HISTORIC AND DESIGN REVIEW COMMISSION

HDRC CASE NO: 2016-420
ADDRESS: 435 CEDAR ST
LEGAL DESCRIPTION: NCB 2968 BLK 3 LOT A9
ZONING: RM-4 H
CITY COUNCIL DIST.: 1
DISTRICT: King William Historic District
APPLICANT: James Breaux
OWNER: Alex Mata
TYPE OF WORK: Demolition of a non-contributing accessory structure and construction of a new accessory structure

The applicant is requesting a Certificate of Appropriateness for approval to:

1. Demolish the existing, side yard accessory structure and carport.
2. Construct a new, side yard accessory structure and carport.

SITE PLAN - PROPOSED

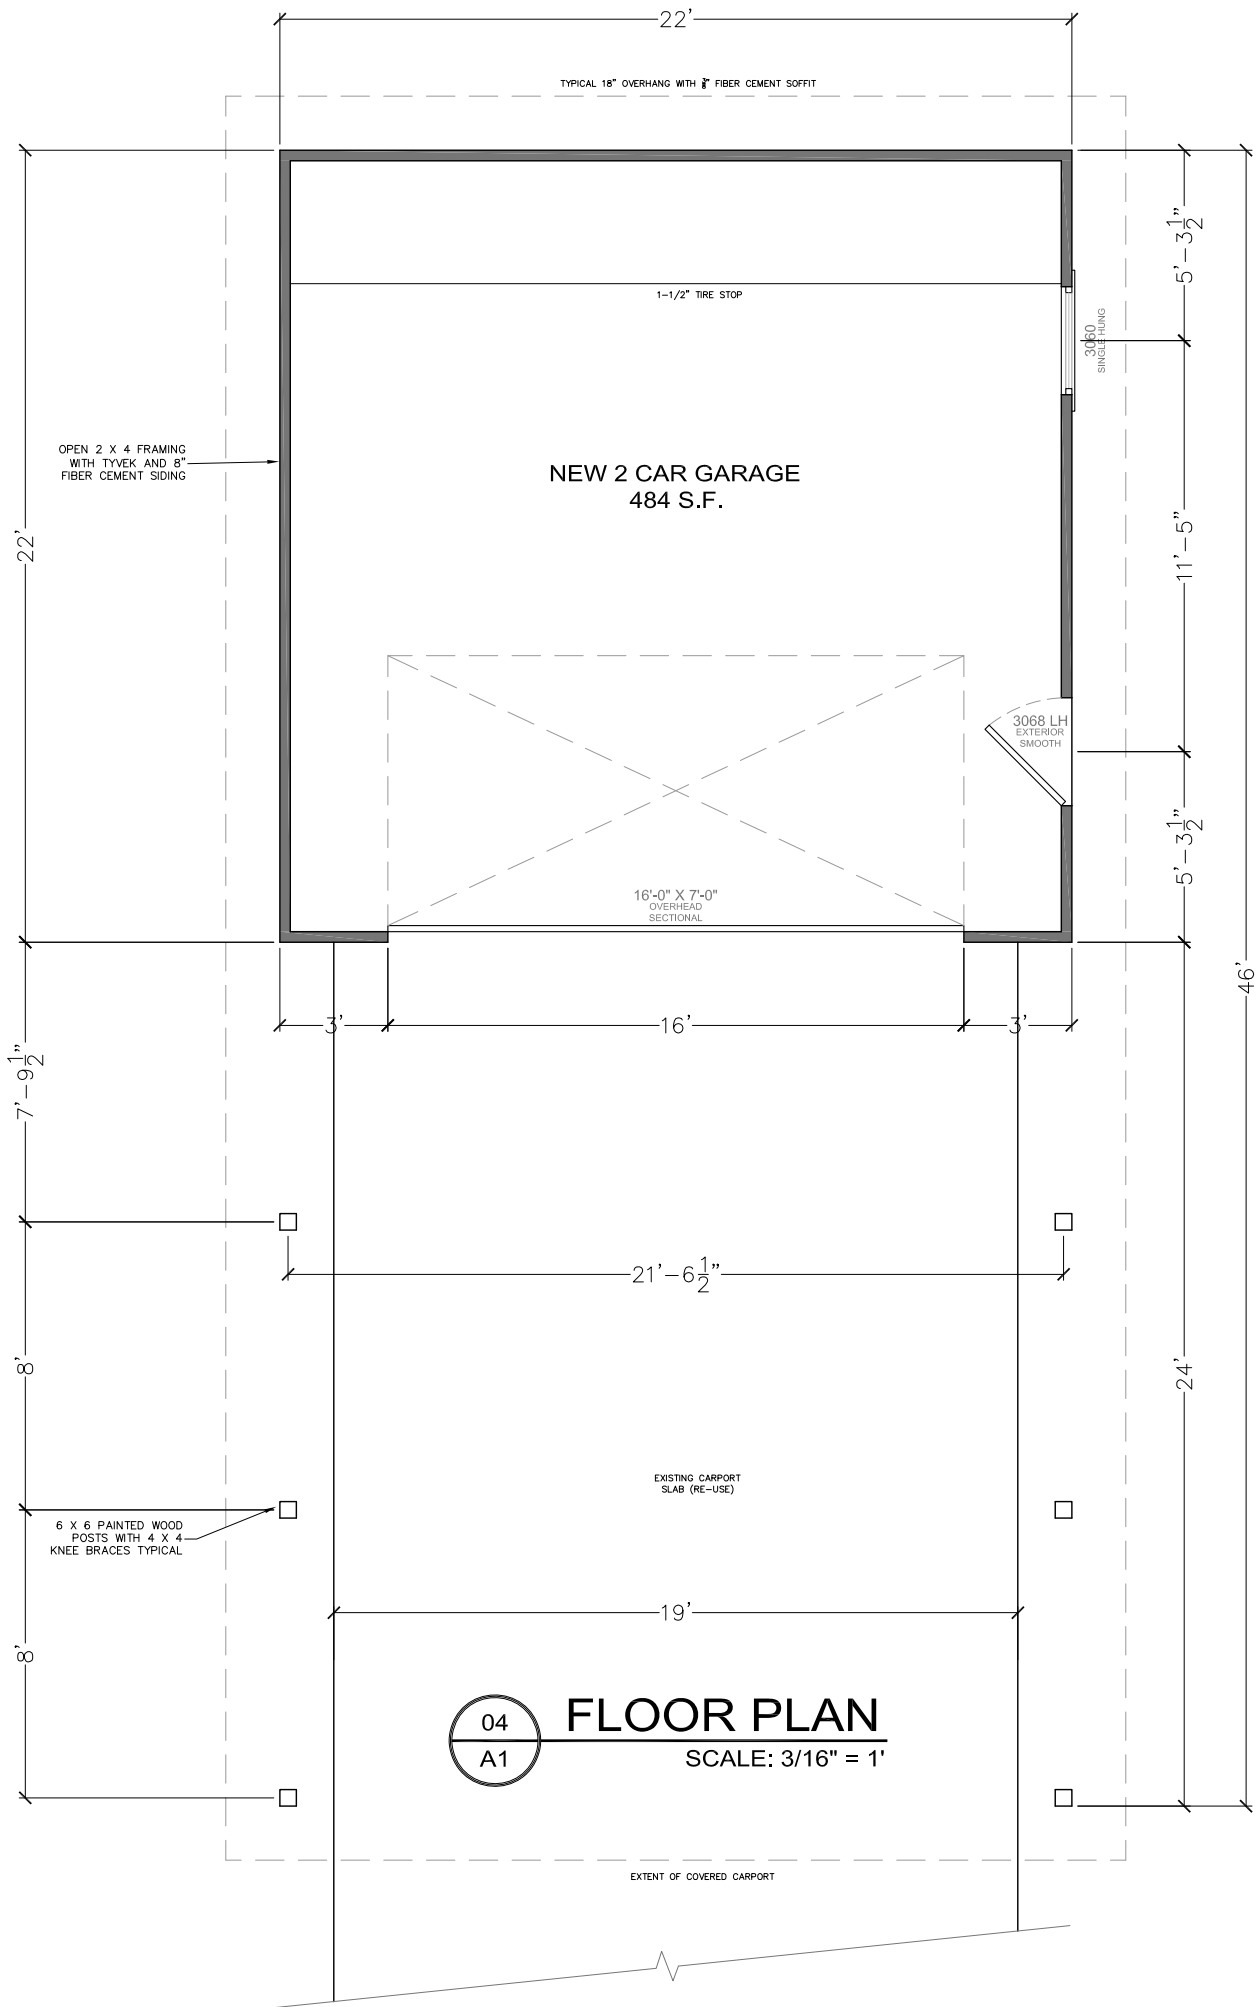
- g. **SETBACKS & ORIENTATION** – The applicant has proposed a setback from the rear property line of five (5) feet and has proposed to orient the accessory structure in the same manner as the previous. While this orientation is not consistent with the historic example found on this block of Cedar Street, the unique lot size and shape limit an orientation, placement and setback that is consistent with historic examples.

EAST ELEVATION

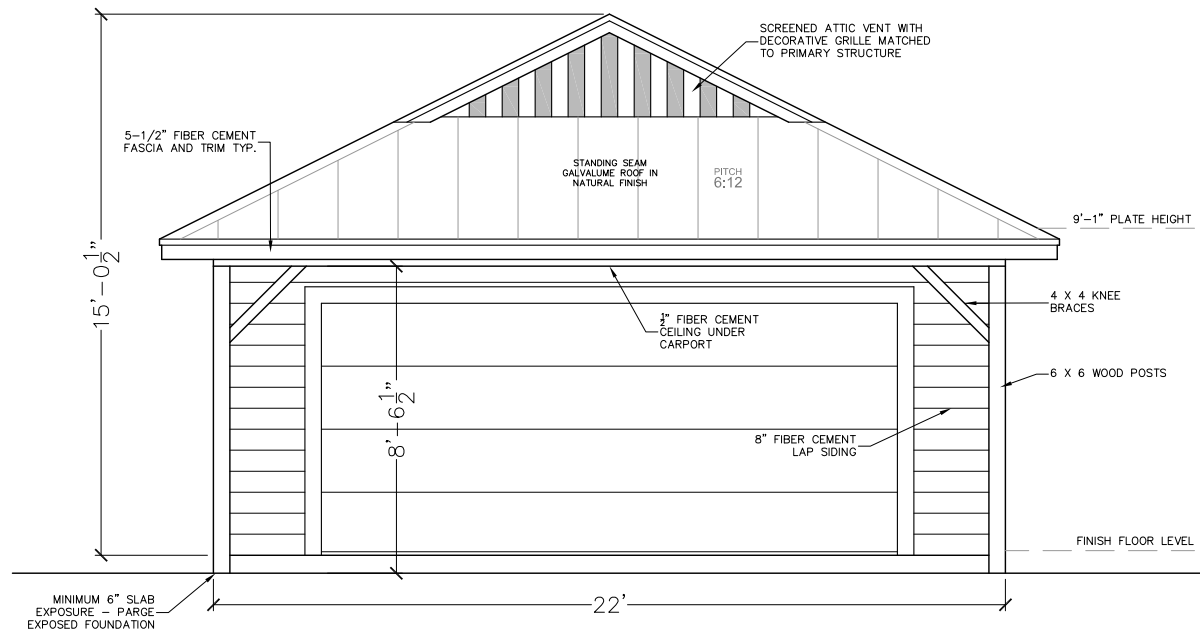
- f. **CHARACTER** – The applicant has proposed for the new accessory structure to feature Craftsman style elements as well as materials that include a galvalume standing seam metal roof, fiber-cement siding, fiber-cement soffits and trim, one wood one over one window, and a smooth, metal-clad garage door and a 16'x7' paneled overhead section garage door. Staff finds the applicant's use of fiber-cement siding and a wood window appropriate; however, staff finds that the applicant should provide additional information regarding to proposed metal door and include carriage style garage doors in the place of an overhead rolling door.

- i. That the applicant incorporate any salvageable wood elements from the existing accessory structure into the construction of the new accessory structure.
- ii. That the applicant provide additional information include a profile for the proposed side door.
- iii. That the applicant install wood carriage doors or a wood garage door to be approved by staff in place of the proposed overhead metal rolling door.

EAST ELEVATION - MASSING COMPARISON

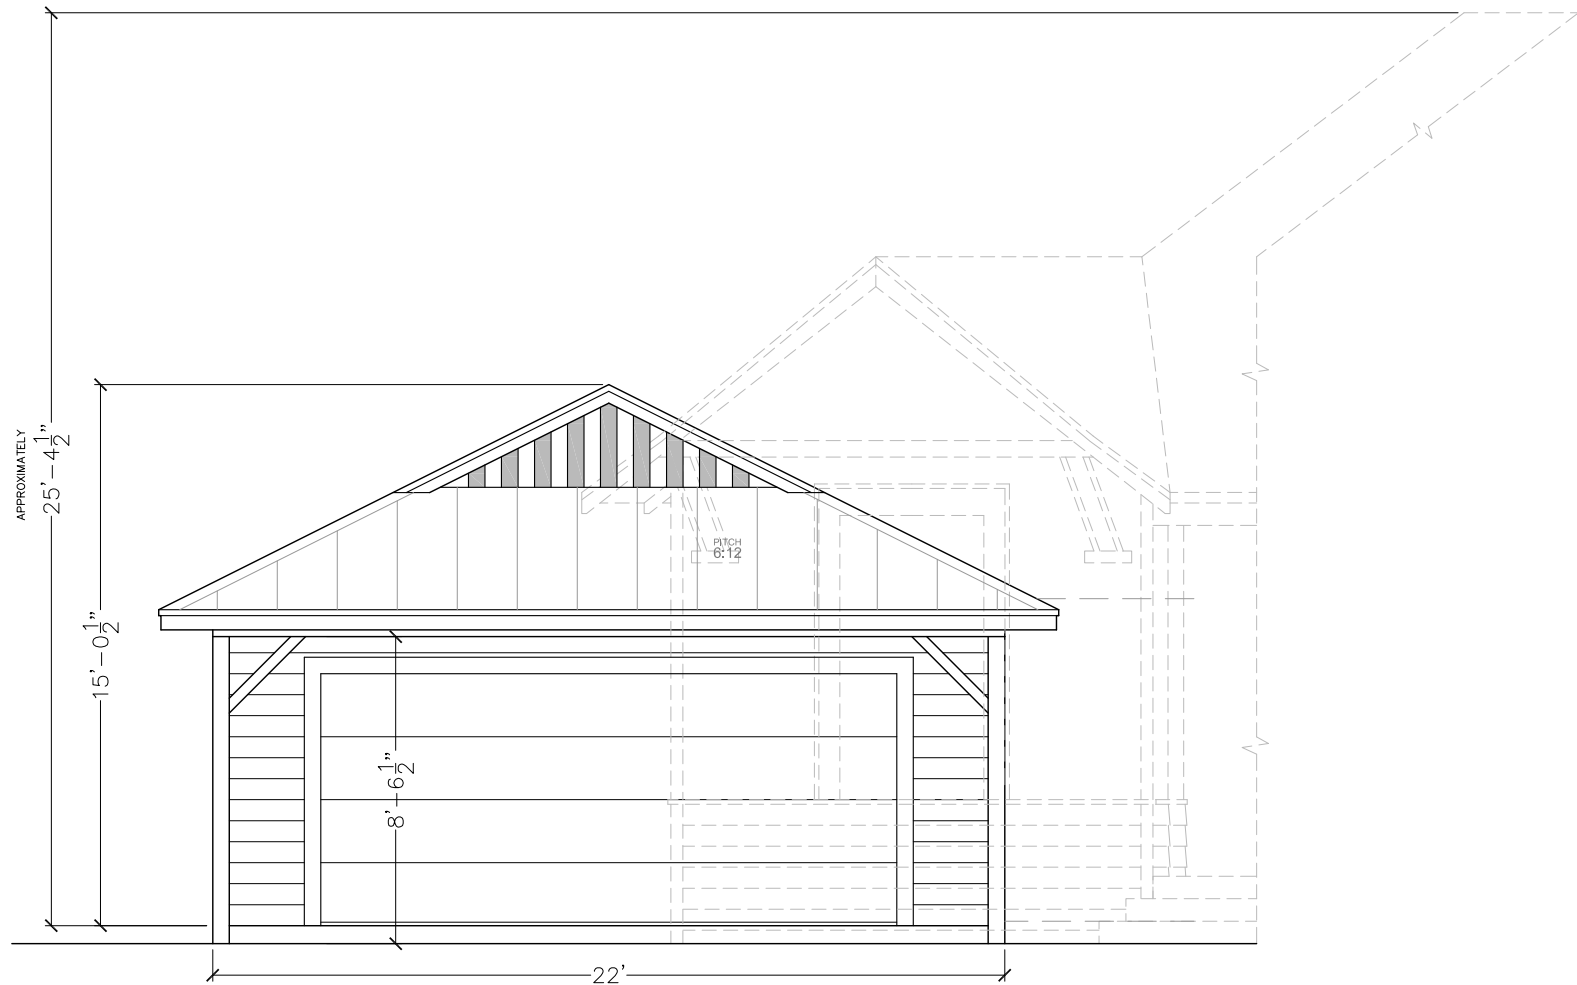
- d. **MASSING & FORM** – According to the Guidelines for New Construction 5.A.i., new garages and outbuildings should be designed to be visually subordinate to the primary historic structure in terms of height, massing and form. The applicant has provided a massing diagram noting the overall height of the addition at 15' – 0 ½" with a width of 22'. The applicant's proposed massing is consistent with the Guidelines.
